UNITED STATES PATENT AND TRADEMARK OFFICE

APPLICATION NO.	FILING DATE	FIRST NAMED INVENTOR	ATTORNEY DOCKET NO.	CONFIRMATION NO.
10/622,346	07/19/2003	Saravuth Sirinorakul	NSE006 US	4811

Office Action Summary

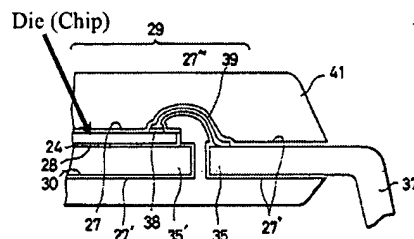
5. Claims 1, and 3 are rejected under 35 U.S.C. 102(b) as being anticipated by US Patent No. 5,013,688 to Yamazaki et al.

Yamazaki et al. teach a semiconductor die package (Figs. 3 and 4), comprising:

a semiconductor die (Fig. at right);

a leadframe (29; Figs. 3(B) & 4);

a capsule (shown as (41) at right)

enclosing the die and a portion of the leadframe.

Yamazaki et al. further teach that the surface of the leadframe is roughened (Col. 2, lines 31 – 41), which would have resulted

in enhanced adhesion. Yamazaki et al. do not teach that the roughened surface is achieved by chemical etching. However, this is considered a product-by-process limitation. "Even though product-by-process claims are limited by and defined by the process, determination of patentability is based on the product itself. The patentability of a product does not depend on its method of production. If the product in the product-by-process claim is the same as or obvious from a product of the prior art, the claim is unpatentable even though the prior product was made by a different process." In re Thorpe, 777 F.2d 695, 698, 227 USPQ 964, 966 (Fed. Cir. 1985).
